TO: Transportation, Infrastructure, Energy and Environment Committee
FROM: ^{GO} Glenn Orlin, Deputy Council Administrator
SUBJECT: Facility planning review—Goldsboro Road Pedestrian and Bikeway Improvements

RE: Goldsboro Road Pedestrian and Bicycle Improvements Project Phase I Facility
Planning

Goldsboro Road Pedestrian and Bicycle Improvements Study – Facility Planning Phase I

Figure 3: Typical Section for Alternative 2 (Preferred Alternative)

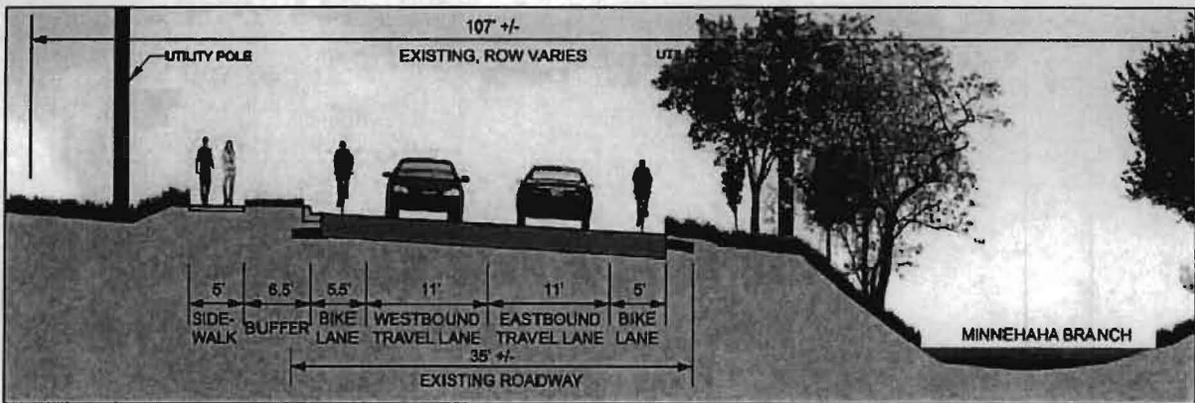
We concur with MCDOT's evaluation of the Goldsboro Road study area, which found that there is a need for better pedestrian and bicycle safety and connectivity, and with their selection of Alternative 2 as the Preferred Alternative.

Figure 5: MacArthur Boulevard / Goldsboro Road Intersection

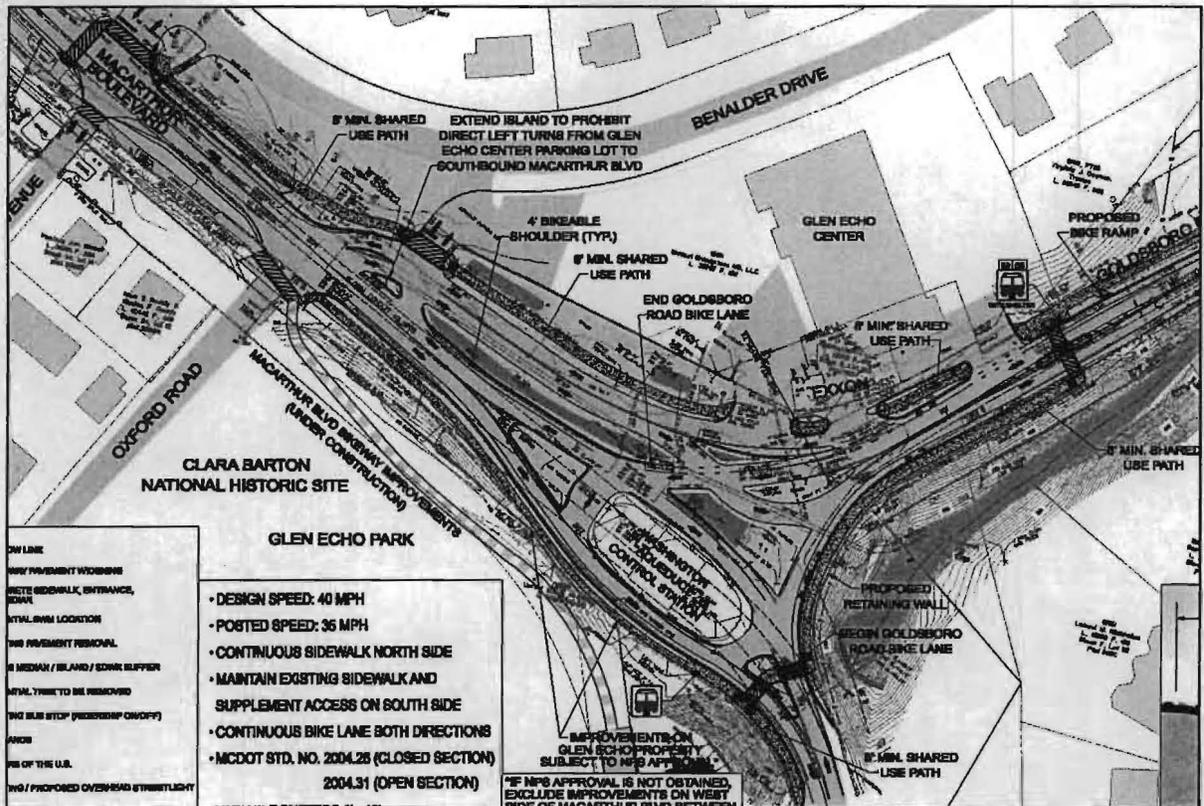
The intersection of MacArthur Boulevard and Goldsboro Road has an unconventional design that functions somewhat like a traffic circle due to the presence of the Washington Aqueduct Control Station, located in the middle of the intersection. The project team evaluated several options for reconfiguring the intersection to simplify pedestrian and bicycle crossing movements, while improving the operation and safety of all intersection users. All of the options were deemed infeasible because each would have routed traffic on top of the existing aqueduct in areas that could be damaged by heavy truck traffic. To accommodate pedestrian and bicycle transitions between Goldsboro Road and MacArthur Boulevard, shared use paths are provided on both sides of Goldsboro Road and connect to crosswalks at MacArthur Boulevard (see Figure 5). This is not ideal, but the constraints at the intersection are beyond the scope of this study to address.

MCDOT adequately addressed most of the comments that Planning staff made during the course of the Facility Planning Phase I study. Therefore, we do not have any additional recommendations for improving the study. However, we do believe that a future facility planning study is needed to further evaluate the unconventional intersection of MacArthur Boulevard and Goldsboro Road.

1. The Goldsboro Road Bicycle and Pedestrian Improvements Study should proceed to Phase II of the facility planning process to develop a detailed design for the completion of the Preferred Alternative (#2).
2. MCDOT should conduct a future facility planning study to further evaluate ways to reconfigure the intersection of MacArthur Boulevard and Goldsboro Road to simplify pedestrian and bicycle crossing movements and improve the operation and safety for all intersection users.

FIGURE 5 | PRE-SELECTION FOR INTERESTED BUT CONCERNED

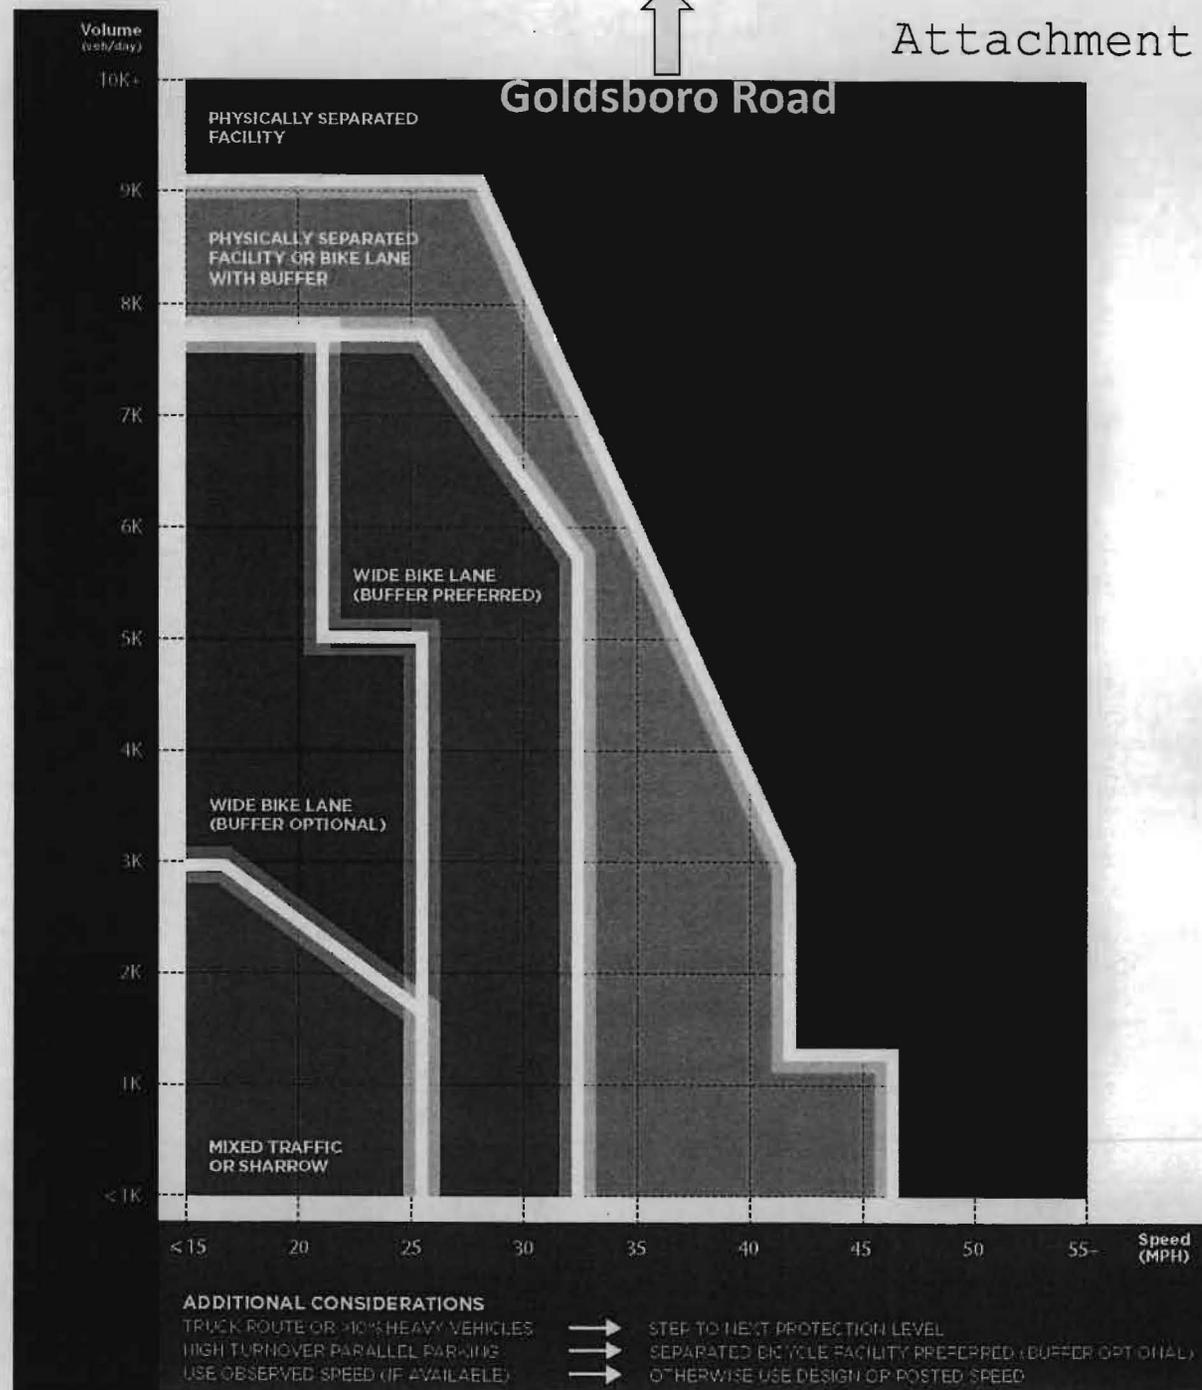
The Bicycle Planning Guidance that the Planning Board reviewed on September 4, 2014 includes two graphs to identify the types of bicycle facilities that are most appropriate under different traffic speed and traffic volume conditions: one graph for “Confident Cyclists” and another for the “Interested but Concerned” population (Attachment 2)¹. Since the posted speed limit on Goldsboro Road is 35 mph; the average daily traffic (ADT) is approximately 11,500 between MacArthur Boulevard and Massachusetts Avenue and is 16,500 between Massachusetts Avenue and River Road, bike lanes are sufficient to address the needs of the “Confident Cyclist” population, but are likely insufficient to meet the needs of the “Interested but Concerned” population, who would prefer a physically separated bicycle facility, such as a cycle track or a shared use path, to ride comfortably on Goldsboro Road. However, either facility type would require additional paved areas and will increase the environmental impacts adjacent to a tributary.

FIGURE 1 | TYPES OF BICYCLISTS AND THEIR FACILITY COMFORT LEVELS

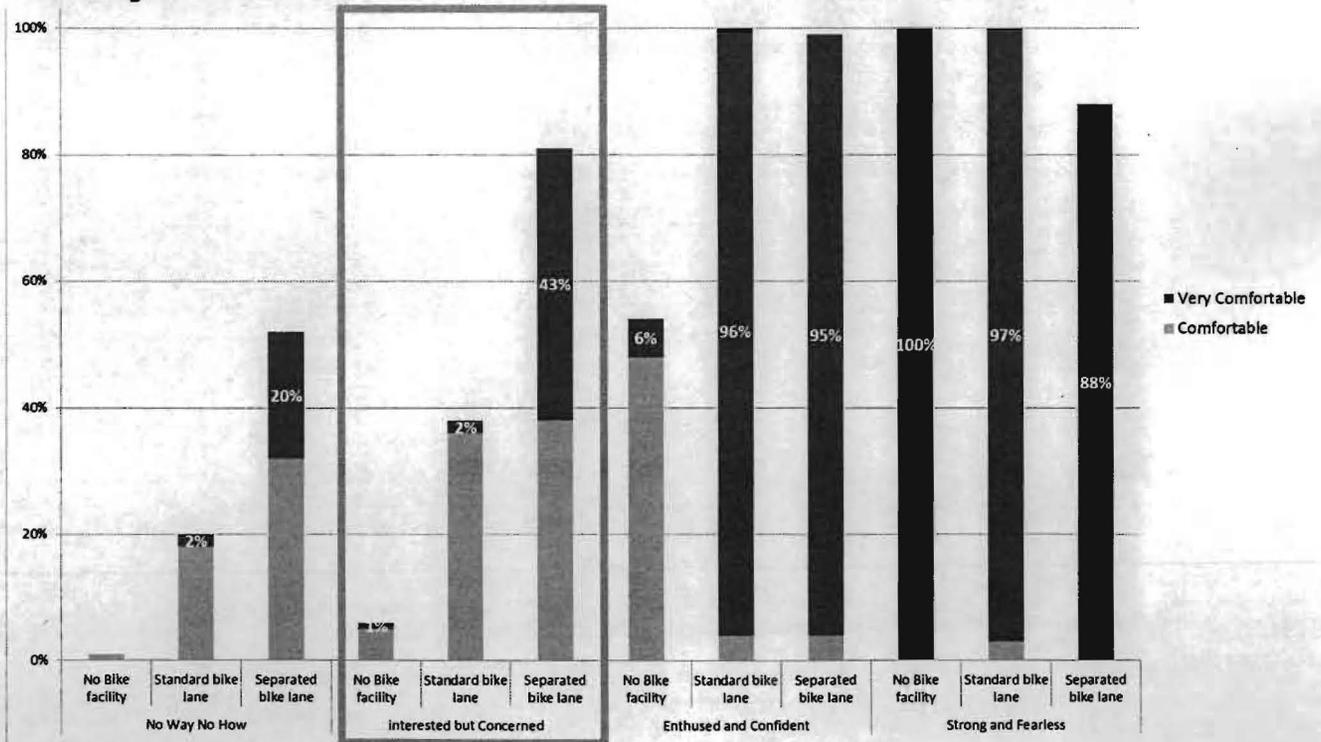
A key is to cater to the needs not only of the “strong and fearless” and “enthused and confident” bicyclists—who together comprise a small proportion of the general population—but of the “interested but concerned” riders as well, who comprise the majority of existing and potential bicyclists. The Portland State research notes that while 96-97% of “strong and fearless” and “enthused and confident” bicyclists are “comfortable” or “very comfortable” with standard bike lanes, less than 40% of the “interested but concerned” riders are. However, introducing separated bike lanes—either buffered bike lanes, a cycle track, or a shared use path—raises the comfort level for this group to over 80% (©26).²

Council staff recommendation: During Phase II facility planning DOT should evaluate both Alternative 2 and another alternative that would replace the proposed bike lanes with a cycle track.
